Notice of Potential Product Concern

**CENTERLINE 2100 NEMA LVMCC 100msec Duration Rated ArcShield R Frame
Inability to Turn Off Breaker on Loss of Internal Control Power**

Reference: 2021-01-001

Appendix C Retrofit Part Installation Instructions

Section without the reset button installed:

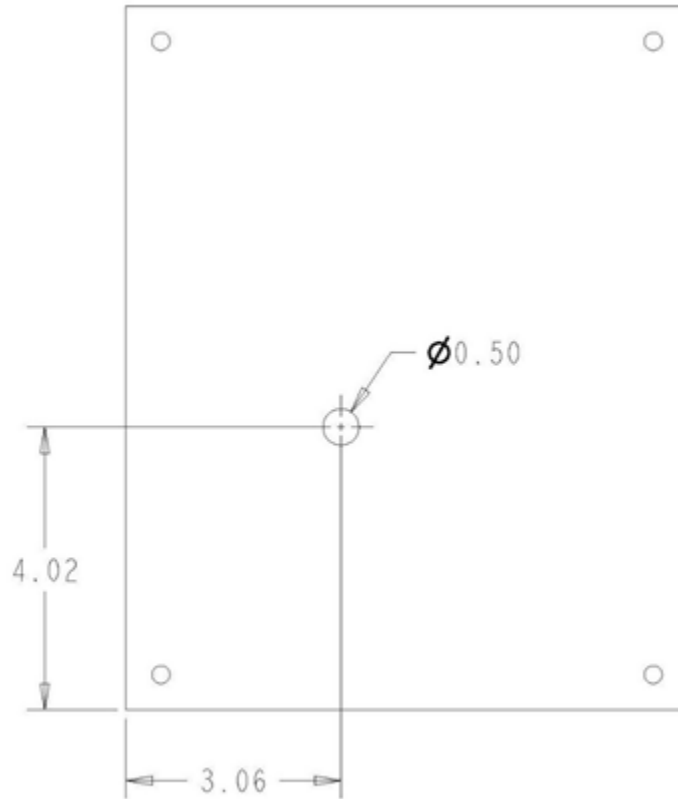
Issue: A reset button to de-energize the R-Frame circuit breaker is missing from the door.

Impact: If a fuse on the control transformer opens, the control station that energizes and de-energizes the circuit breaker will no longer function.

If the control station is no longer functional, the circuit breaker can no longer be de-energized. The door lock on the circuit breaker will not release with the circuit breaker still energized.

Resolution: Install a reset button in the polycarbonate window of the door. The reset button will be positioned over the OFF button of the circuit breaker. This reset button will allow the circuit breaker to be de-energized if a fuse opens on the transformer. The photo below illustrates the position of the reset button on the door.

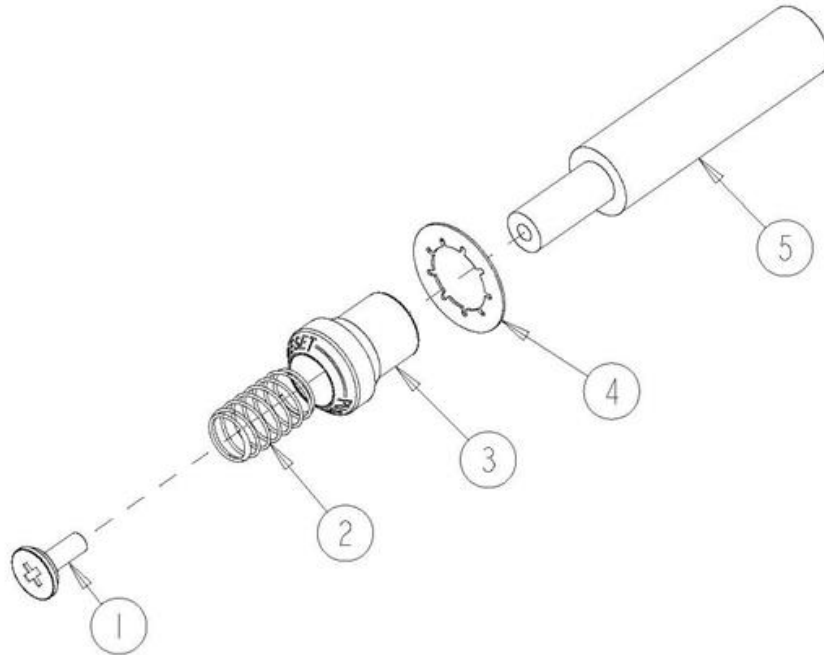
4. Once the hole is added to the window, it can be re-installed on the door. The double-sided tape and the hardware used to mount the window on the door should be re-installed. When installed properly the hole will be in the bottom left quadrant of the door. Please refer to the picture at the beginning of this section for proper orientation.
5. Once the window is back in place, the reset button can be installed. The reset assembly will arrive fully assembled. The picture below shows the reset assembly and identifies the parts. The parts are (1) button screw, (2) spring, (3) bushing, (4) lock ring and (5) reset extension.

View of installed reset from front side of the viewing window.

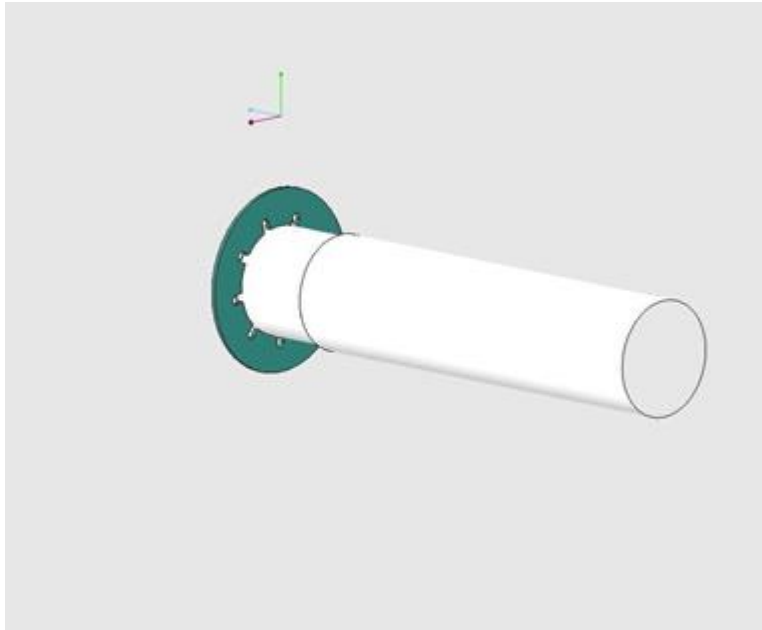
6. To install the reset, place the bushing into the hole that was cut into the polycarbonate window until the bushing sits flush in the window. The lock ring will then be placed on the bushing from the inside side of the door until it sits flush against the polycarbonate window. If properly installed the reset bushing should be held in place.
7. Once the bushing is in place, the spring can be placed in the bushing.
8. The reset screw is then placed in the bushing to hold the screw inside the bushing.
9. With the reset screw and spring being held in place, the reset extension is then screwed onto the reset screw. If properly installed, the front of the reset screw should be flush with the front of the bushing. The reset extension should be held securely onto the reset screw. Refer to the pictures below to see what the installed button should look like.
